State of Utah
DEPARTMENT OF NATURAL RESOURCES
DIVISION OF OIL, GAS AND MINING

Re: Approval of Reclamation Plans, Mountain Coal Company, Gordon Creek 2, 7, & 8 Mines, ACT/007/016, Folder #3, Carbon County, Utah

TECHNICAL ANALYSIS AND FINDINGS RECLAMATION PLAN

**MOUNTAIN COAL COMPANY
GORDON CREEK #2, #7, #8 MINES
ACT/007/016**

PROJECT: Gordon Creek #7 Portal Area

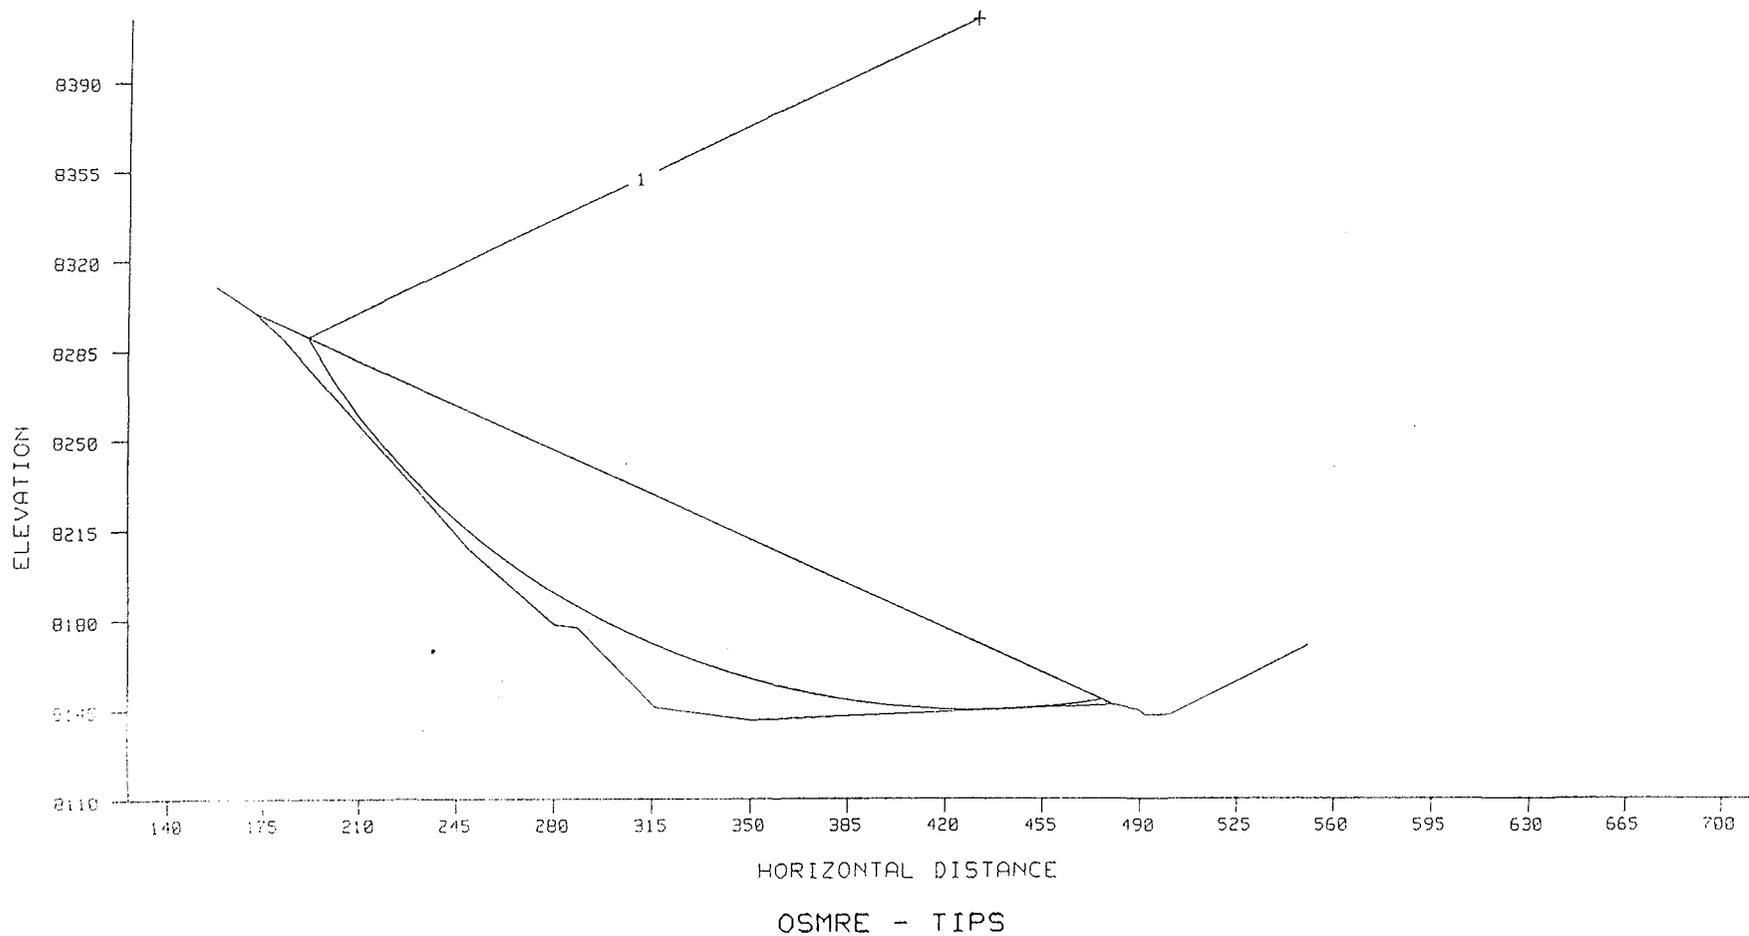
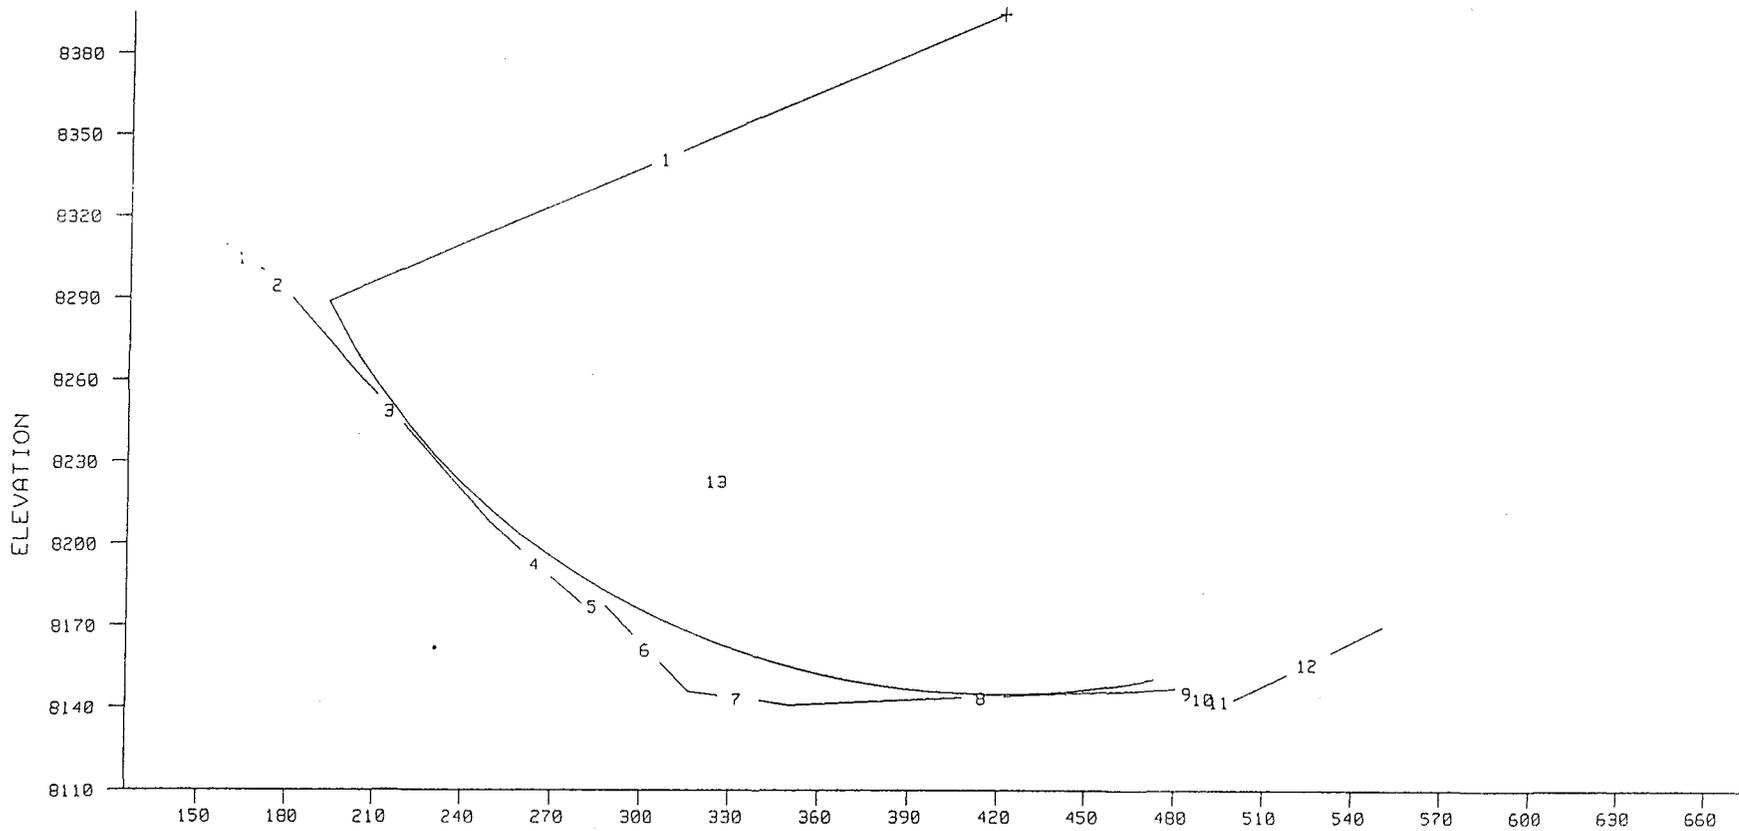
Through modeling and analysis, it was found by the Division that saturated conditions dramatically affect the slope angle and height allowable in comparison to unsaturated conditions where cohesion can be developed. OSM analysis varied the extent to which the fill areas were saturated and theorized that a significant change in the slope could be obtained under certain circumstances. Under certain conditions, the Division agrees that such slopes could be achieved. However, modeling and analysis also indicated that only small changes in the phreatic line (saturation elevation and gradient) would drastically affect these

As an example of the problems associated with the saturation level, a cross section taken from the plan and indicated on the drawings as Section 3 was used to show how saturation can affect slope stability. The soil parameters used in the analysis are taken from the plan and are shown in the sample data labeled as Gordon Creek #7 Portal Area, Saturation limited to top of MSHA bench. This example shows a slope from the top of the cutslope above the portal area projected at the least slope possible, to where it encroaches on the stream channel. The slope shown is a approximately 2:1 slope. Dry, the embankment exceeds a 1.3 FS. The graphic section provided with the example, with a phreatic line projecting from the MSHA bench to the toe of the fill indicates a FS of 1.2. A second graphic, with the slope fully saturated, indicates a FS of .69, resulting in slope failure. Refer to data and figures found in Appendix I to the this technical analysis.

Figure 3 - #7 Portal Area as Proposed, Looking East

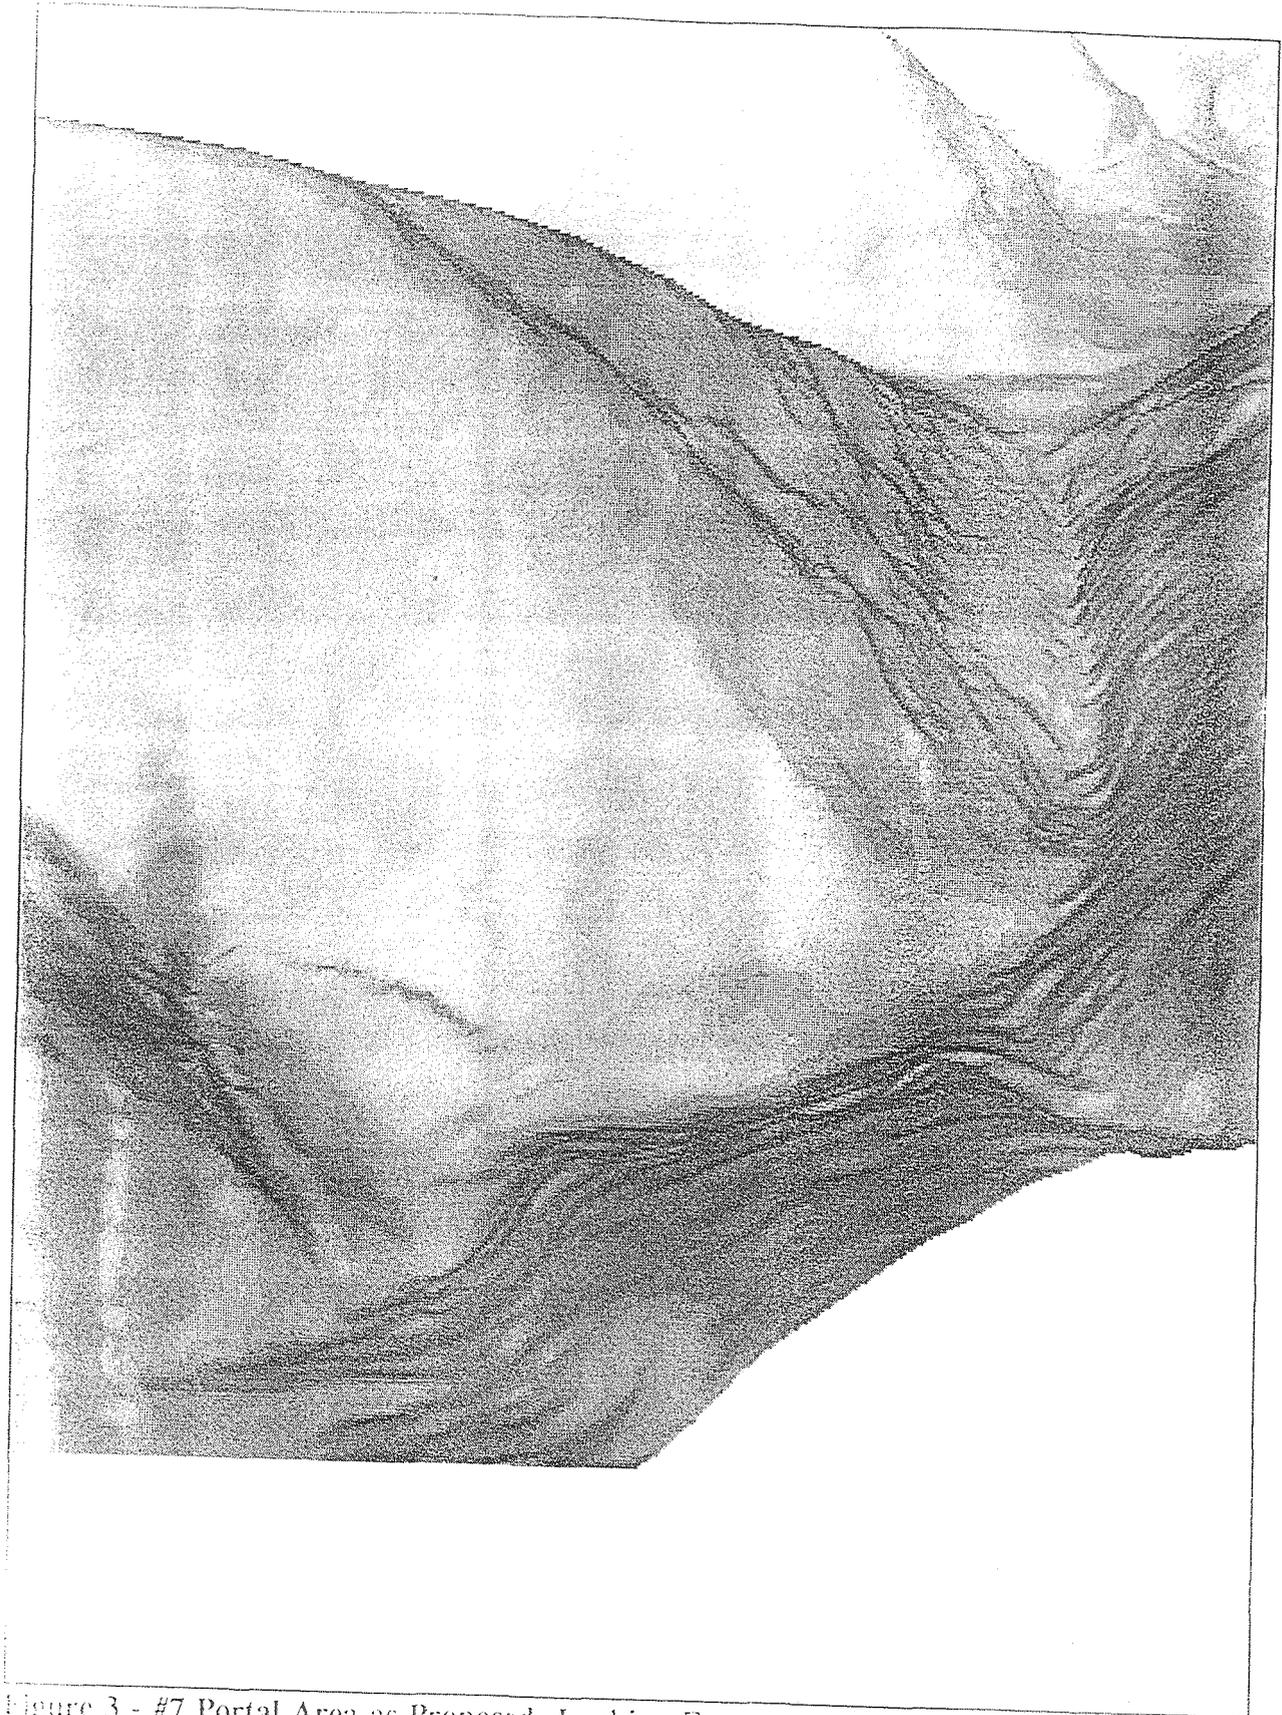
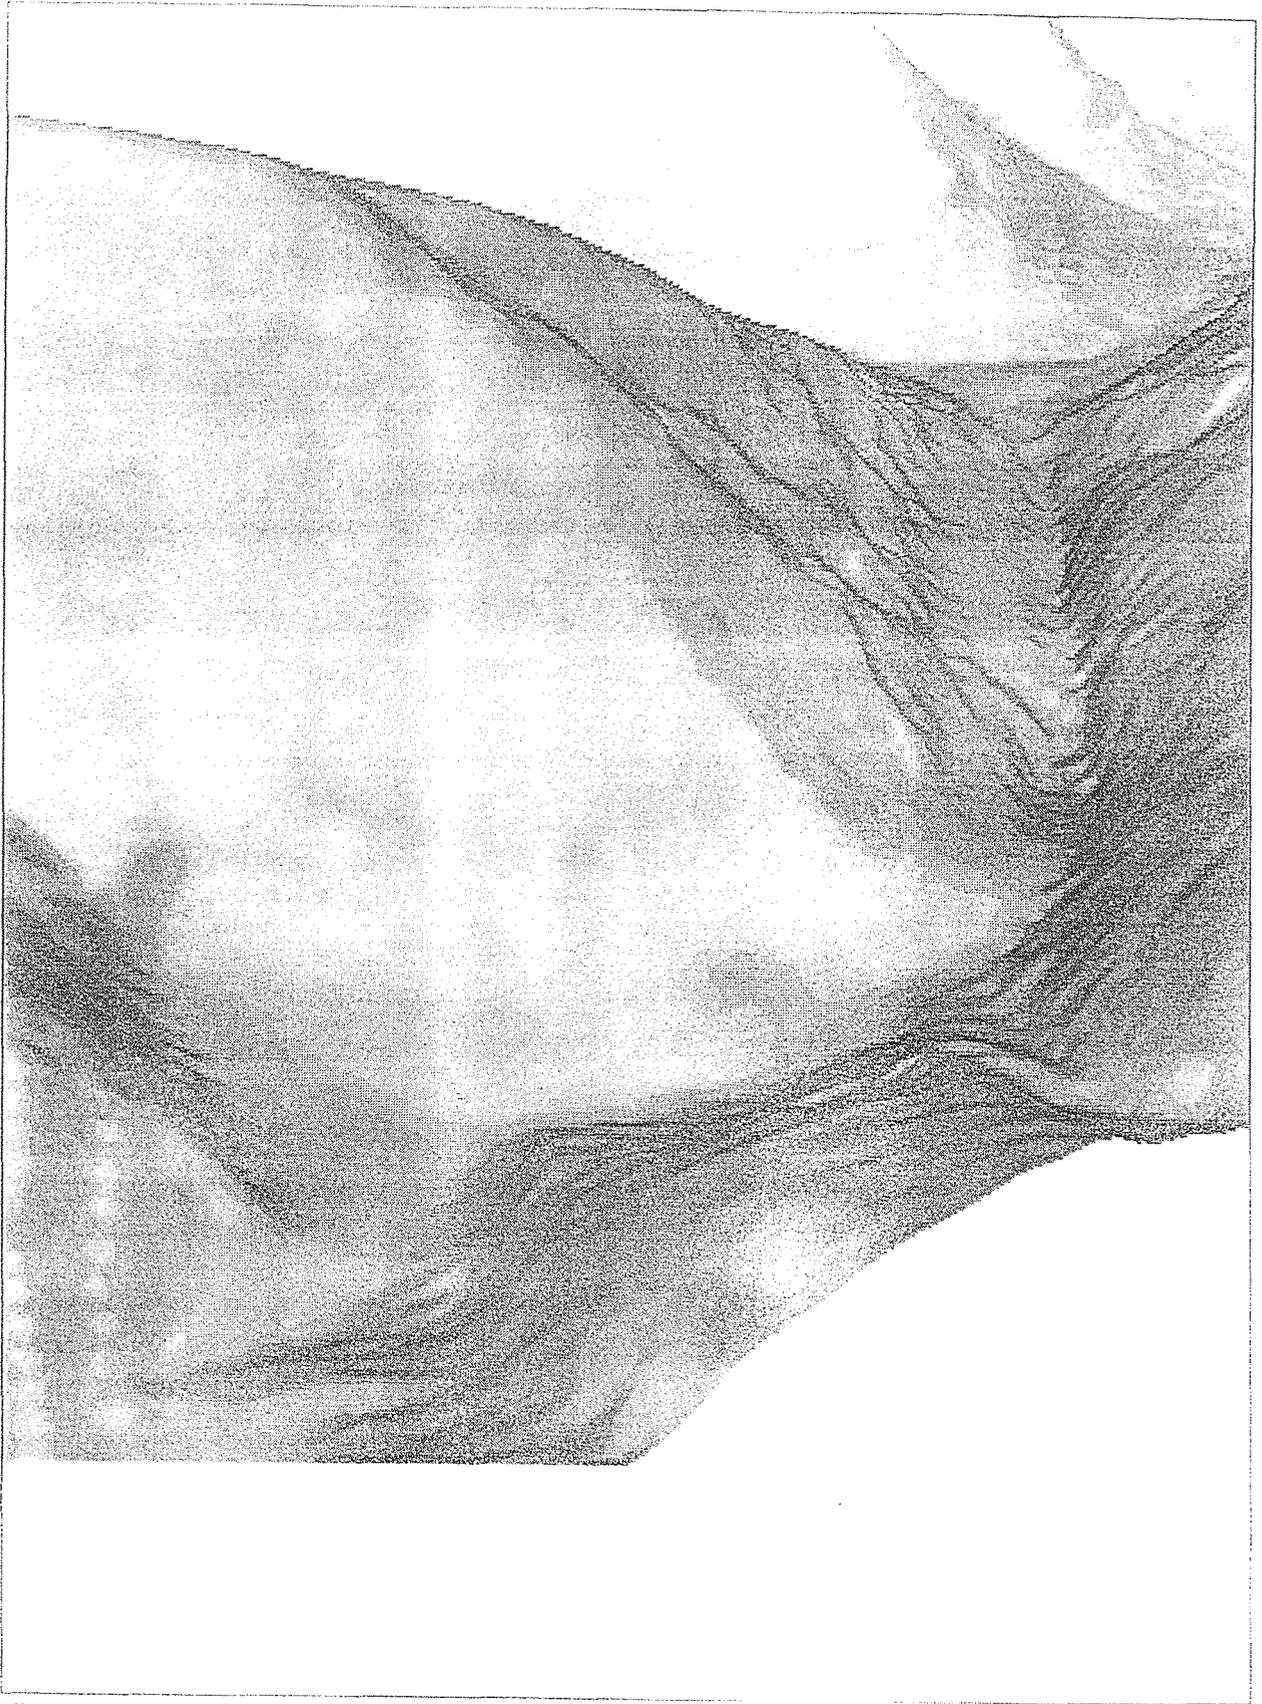
Surface contours within the site were revised by the Division to determine to what extent additional material may be available, within the currently disturbed area, to minimize or further reduce the extent and the height of the cutslopes associated with backfilling and grading. The Division found that material within the site is sufficient to further backfill the #7 Mine portal area to the extent that would be allowed by reducing the factor of safety from 1.5 to 1.3. The revised contours were used only to roughly approximate changes to the entire facilities that would occur. These revised contours, developed approximately 42,000 additional cubic yards of material which could be used for fill within the cutslope areas. Of this, approximately 14,000 cubic yards were used in the #7 Mine portal area with the remainder of the material used in and around the #2 Mine portal area. This material was derived from the gentle slopes adjacent to and to the southeast of the #2 Mine portal area. EarthVision volumetric mass balance calculations from revision of the surface contours are as found in the Volumetrics Report attached to this TA in Appendix I. These calculations only consider the movement of material in comparison to the final reclamation contours proposed by the operator and as such do not relate to the mass balance calculations in the plan used in design earthwork from the mine operation stage to final reclamation. Revision of the proposed surface contours was accomplished by the Division only to determine whether or not additional material could be utilized from within the currently disturbed area.

As part of the backfilling and grading evaluation of the site, the Division considered the elimination or the reduction of cutslopes within the site. The visual effects regarding the placement of additional materials to reduce the vertical extent of cutslopes is not significant in comparison to the final surface configuration as proposed by the operator. To compare the difference, 3-D models looking at the #2 Mine area and the #7 Mine area were developed. Figure 1 shows the #2 Portal area as proposed in the plan while Figure 2 show the site following the relocation of the additional materials. Similarly, Figures 3 and 4, are shown for the #7 Portal area. Unfortunately, digital data was not made available to compare the pre-mining surface configuration or the operational surface configuration to the final reclaimed surface configuration.

Backfilling and Grading, backfilled slopes in the #7 Mine portal area shall be backfilled to the extent possible while maintaining a factor of safety of 1.3. The operator shall determine, based on site conditions, where additional materials may be developed and placed as fill to further reduce or eliminate cut slopes associated with the reclamation plan. Slope measurements and stability analysis based on site conditions during construction shall be provided in conjunction with certified as-built reports or plans demonstrating stability and that backfilling of cutslopes to the extent possible during reclamation activities has been accomplished.
